AGENDA

CITY OF COLUMBIA TENNESSEE
BOARD OF ZONING APPEALS
STAFF REPORT

DOCKET/CASE/APPLICATION NUMBER
22-0183

REQUEST: Conditional Use (Extractive Use in an RS-40 Zone)

Zoning - 02

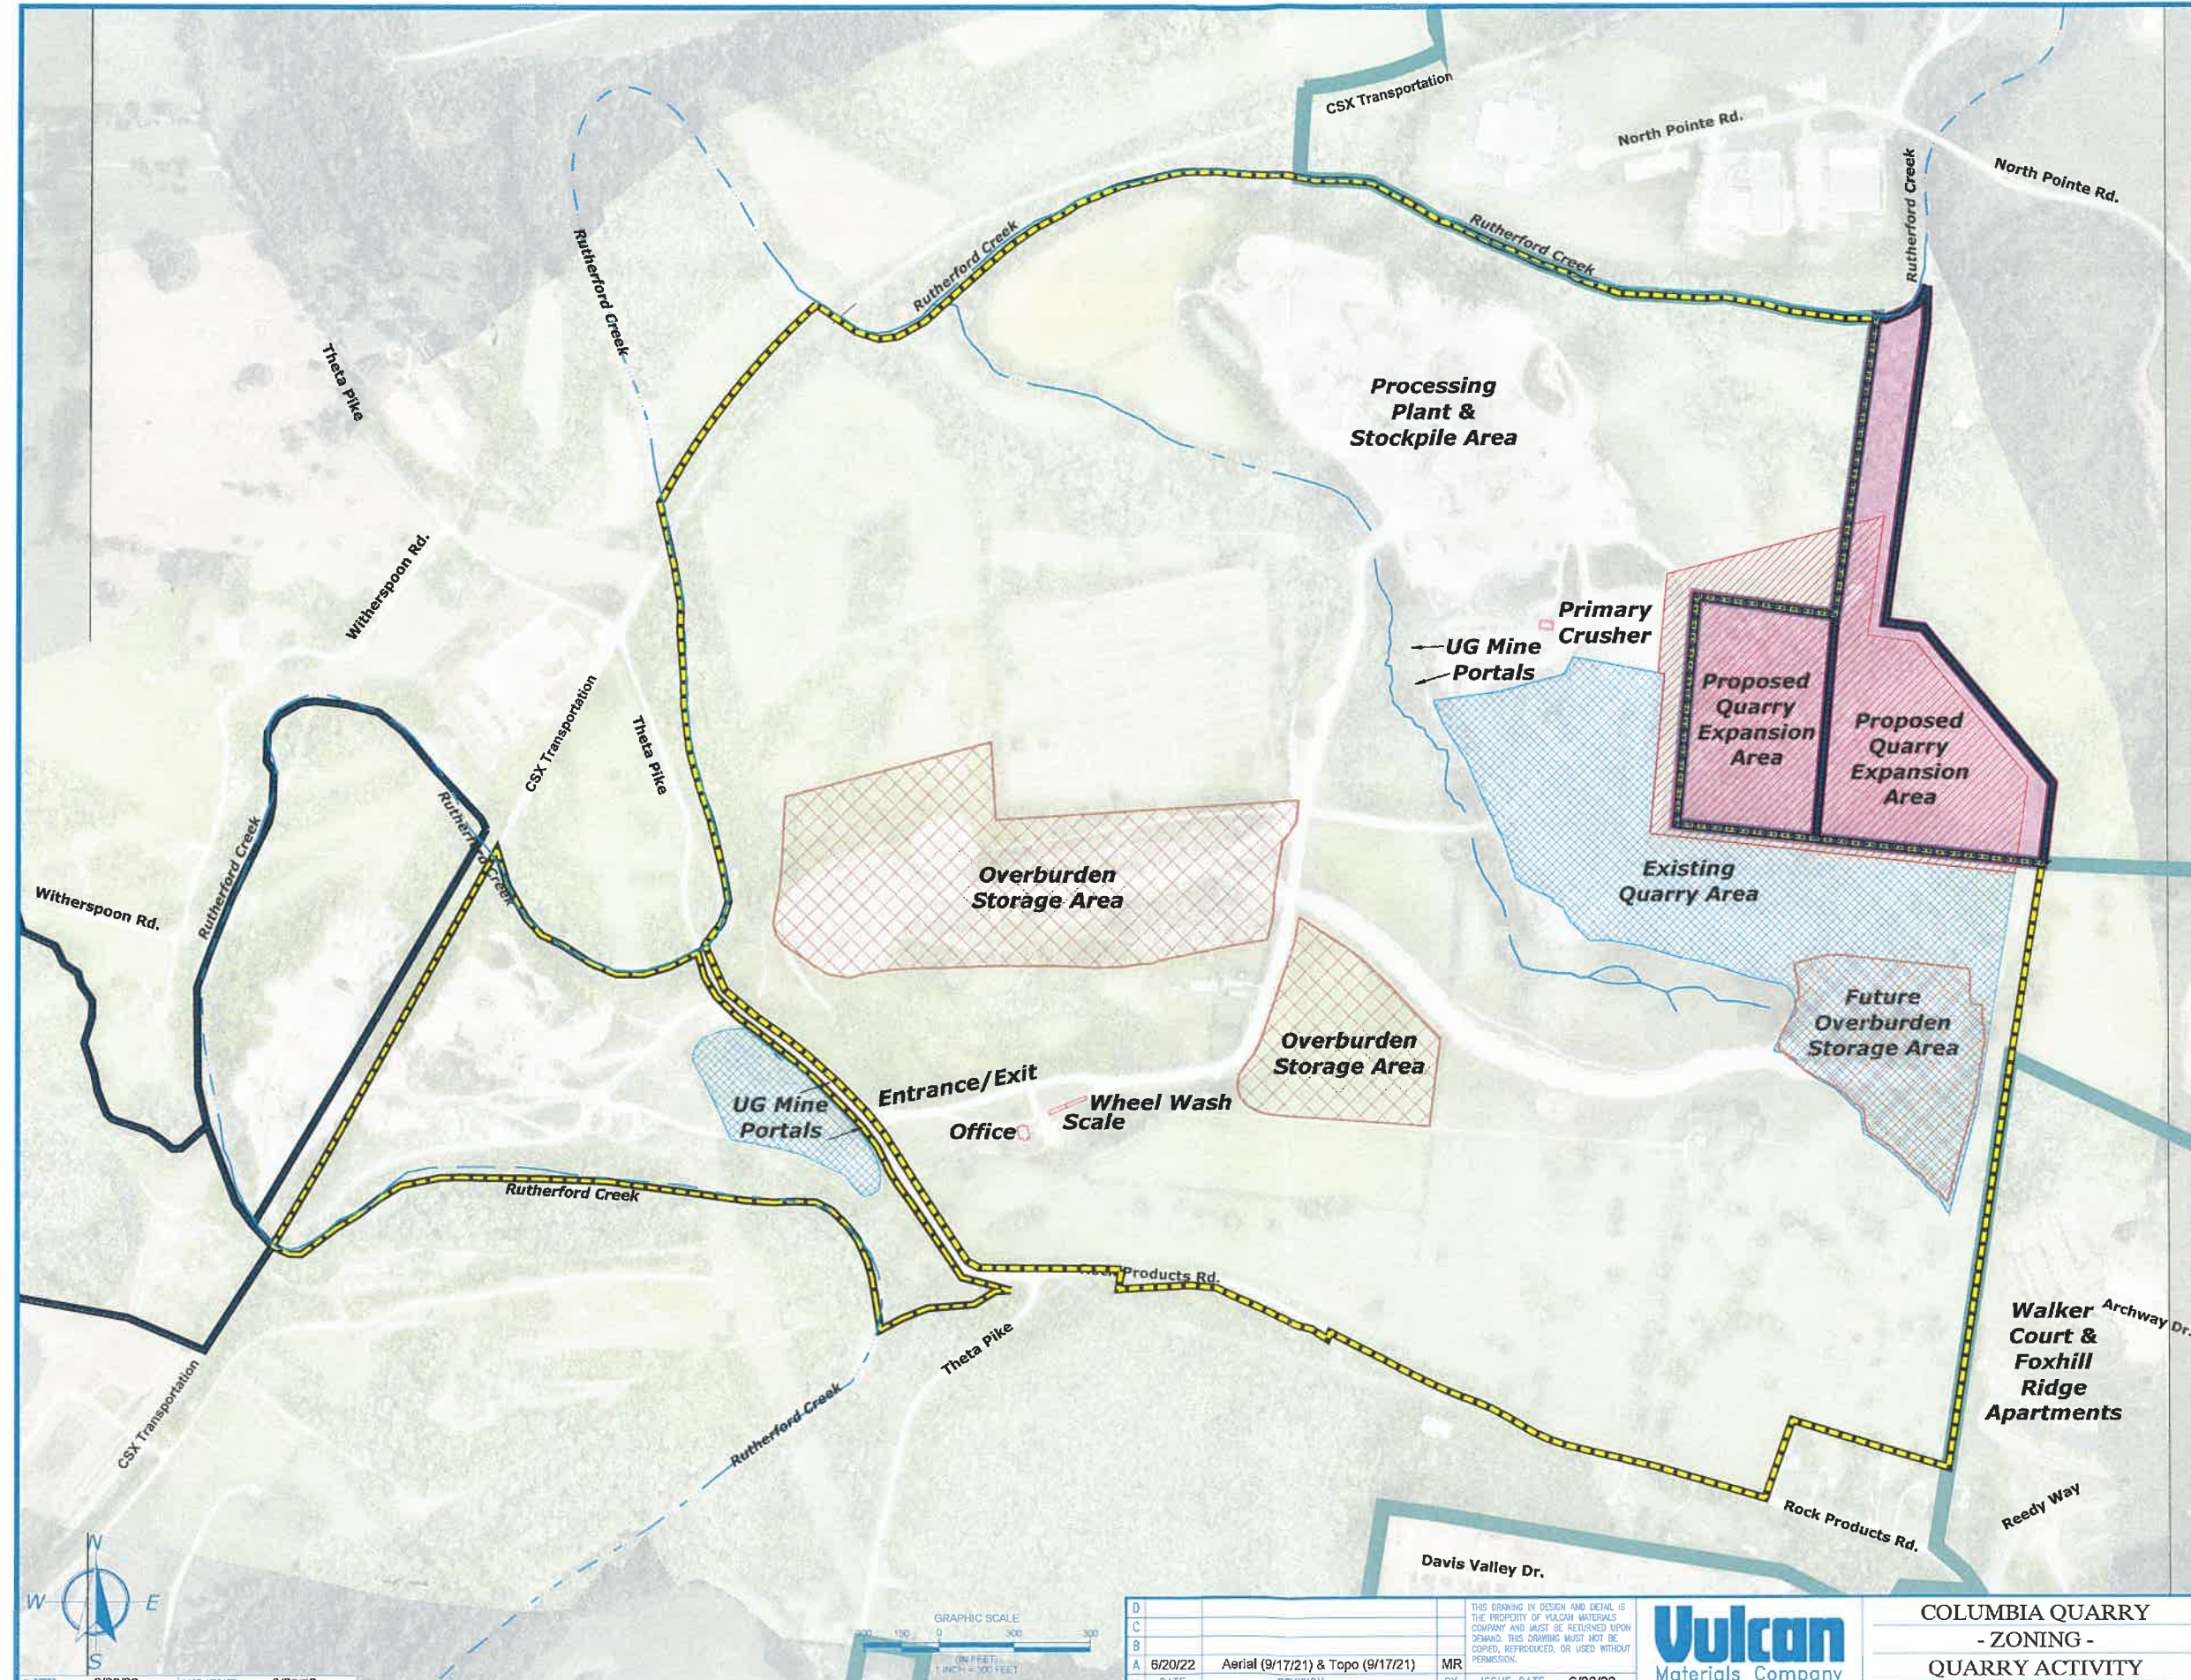
The Zoning Ordinance requires that every mining operation established in the city provide a plan for restoration of the site (8.3.1.C.1). The applicant's plan is illustrated at Exhibit I of the submittal and further described in the letter from the applicant's representative. Specifically, the applicant proposes to reduce the slope of the site using fill materials. The remaining "pit" will become a water feature and the site will be planted with native foliage. The Ordinance does not prescribe technical requirements for restoration of the site. The applicant's proposal appears to be in keeping with industry standard and the common practice for retiring exhausted quarries across Tennessee.

The Ordinance requires that a detailed site plan accompany every request to establish or expand a quarry operation (8.3.1.C.4). The applicant has provided a site plan comprised of Exhibits A through I of the submittal. The plan depicts the existing contours of the site and its vicinity at 2-foot intervals (8.3.1.C.4a and b), the method of drainage (8.3.1.C.4d), and the plan for restoring the site (8.3.1.C.1 and 8.3.1.C.4d).
